MODIFICATION BULLETIN

AIRPL
MODEL
91
Safir

91.3/1
91.3400/1

Elevator, Replacement of coupling plate

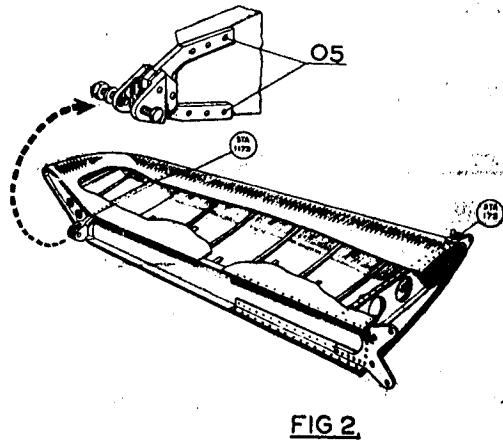
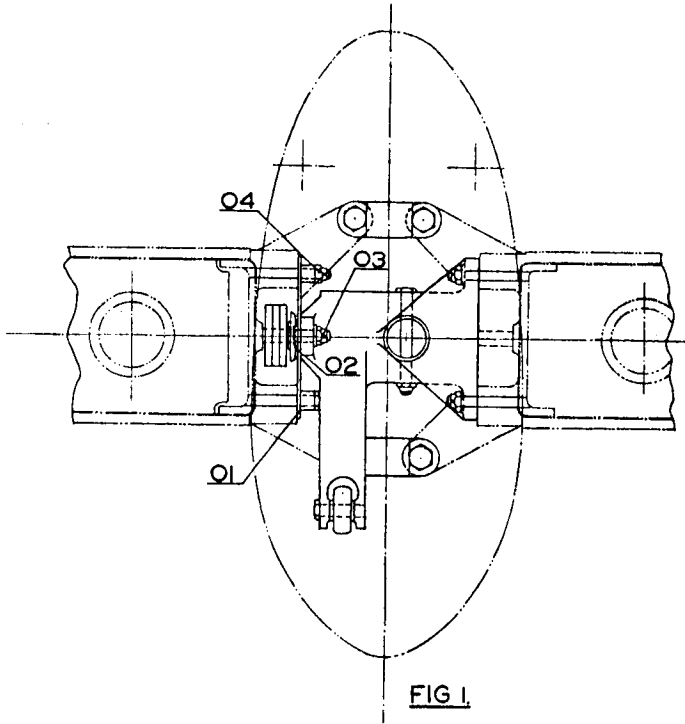
Unfasten the nuts, items 03 and 04 and remove the coupling plate, item 01 according to fig. 1.

Install the new coupling plate 562738, item 01, using a required quantity of washers, item 02, in accordance with fig.1 so that the coupling plate will be secured axially by the center bolt.

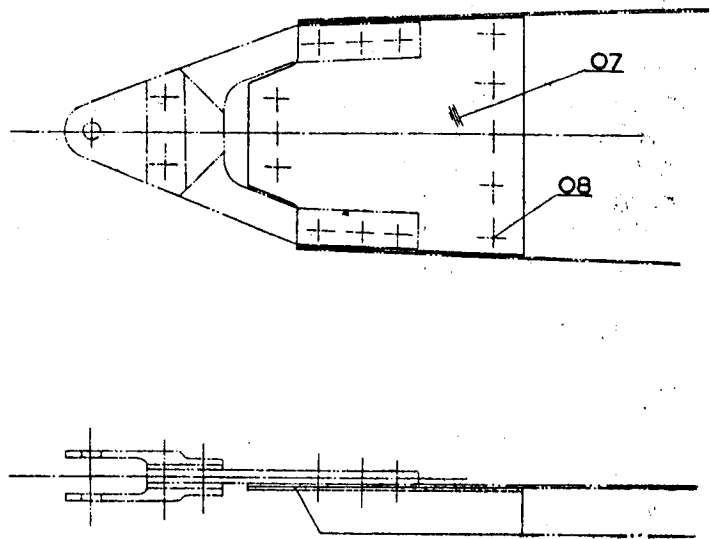
Drill two inspection holes 1,8 in. (ϕ 30 mm) in the panel, item 06 and enlarge the opening adjacent to the rib by filing.

THESE CUT-OUTS SHOULD BE ENLARGED BY FILING IN ORDER TO FACILITATE THE INSPECTION OF EVENTUAL CRACKS.

Thereupon check that the rivets, item 05, are not loose and that no cracks exist in the bend of the rib.

FIG 4.

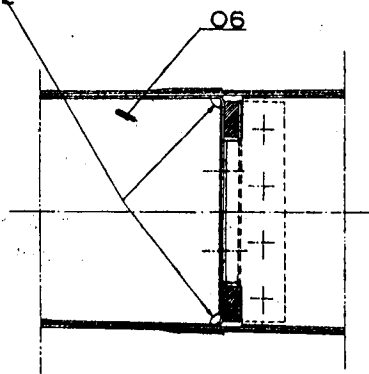
If larger cracks have developed, the rib should be repaired in accordance with fig. 4.

07 1 Reinforcement plate 100x82x0.8

08 8 Rivets 3.2x7 AS 211502
Aluminium 3514-3
